PLANNING & ZONING COMMISSION STAFF REPORT

Public Hearing Date: August 28, 2024
Subject: Case No. SUB-202-0019
Applicant/Owner: Philip Gursky, applicant, representing IMG, LLC, and Twilight Homes of NM, LLC, on behalf of Handy Family Trust, property owner
Case Manager: Desirae J. Lujan, Senior Planner

CASE NO. SUB-2024-0019. Philip Gursky, applicant, representing IMG, LLC, and Twilight Homes of NM, LLC, on behalf of Handy Family Trust, property owner, is requesting Preliminary/Final Subdivision Plat approval for the properties addressed as 114, 117, 118, 119, 120 A & B, 122, and 123 Longview Drive, White Rock, NM. The development proposes a 29-unit, two-story, townhome subdivision on 1.05 acres, combined. The properties, SV A006A, SVA006C, SV A006D, SV A006E, SV A006F, SV A006G, and SV A003C, SV A003D, SV A003E, Sherwood Village, are within the White Rock Town Center (WRTC) Zone District.

Figure 2: Excerpt of Subdivision Plat, Sheet 2

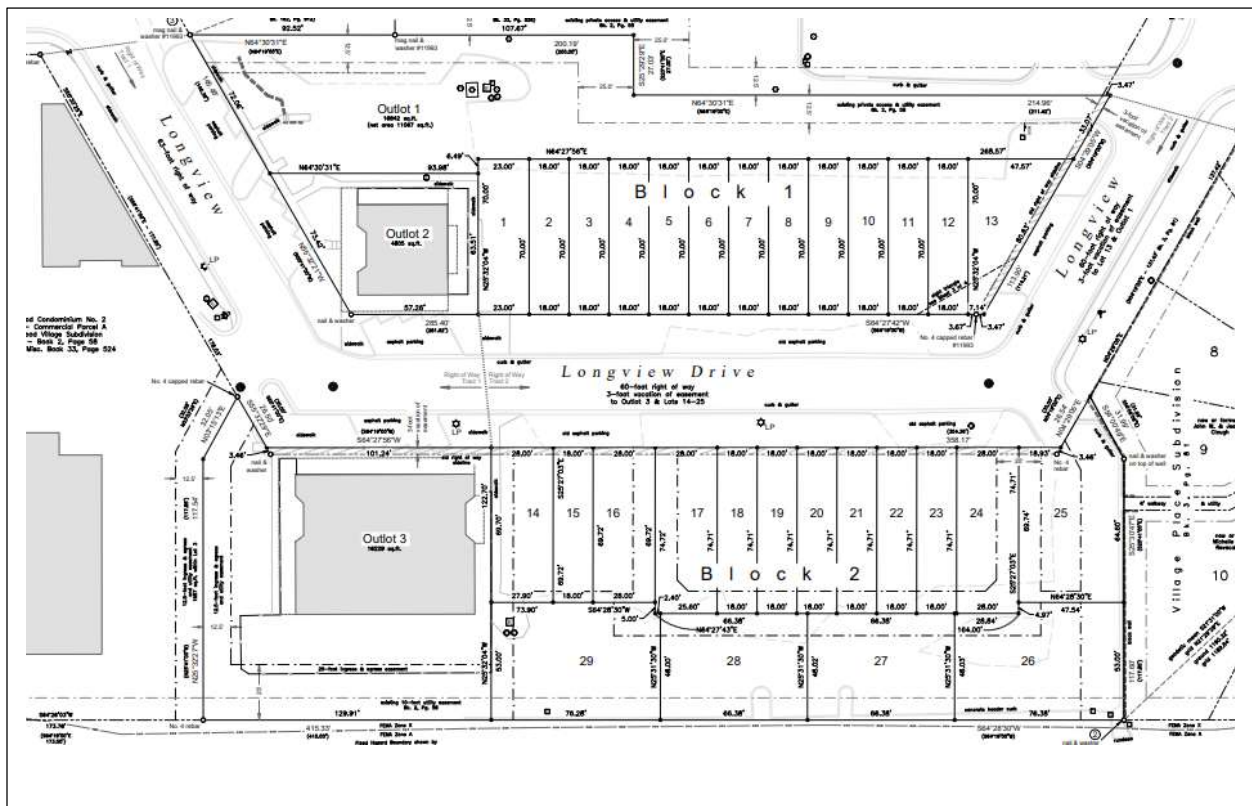
- ***Sheet 1 of 4: A 10-foot maintenance vehicular access road (ingress/egress) and drainage easement shall be granted to the County for vehicular access to SE pond from within the interior streets between Lot 25 and 26. This easement will need to be shown clearly on all sheets in the plat document.***

- ***Sheet 2 of 4: Label the easement for the SE pond areas.***
 - ***Pedestrian access and Easement: Provisions shall be included in the final design to allow construction of additional pedestrian infrastructure allowing access from the property to the east into the proposed Sherwood Rounds development and access to Longview Drive. (See Attachment B – Memorandum Dated August 21, 2024)***

1. ***Before the Final Subdivision Plat is signed and recorded***, Sheet 1 of 4, shall address utility easements by providing a 10-foot maintenance vehicular access road (ingress/egress) and a drainage easement shall be granted to the County for vehicular access to the SE pond from within the interior streets between Lot 25 and 26. The easements must be shown clearly on all sheets in the plat document.
2. ***Before the Final Subdivision Plat is signed and recorded***, Sheet 2 of 4, shall label the easement for the SE pond area.
3. ***Before the Final Subdivision Plat is signed and recorded***, a provision shall be included in the final design to allow construction of additional pedestrian infrastructure allowing access from the property to the east into the proposed Sherwood Rounds development
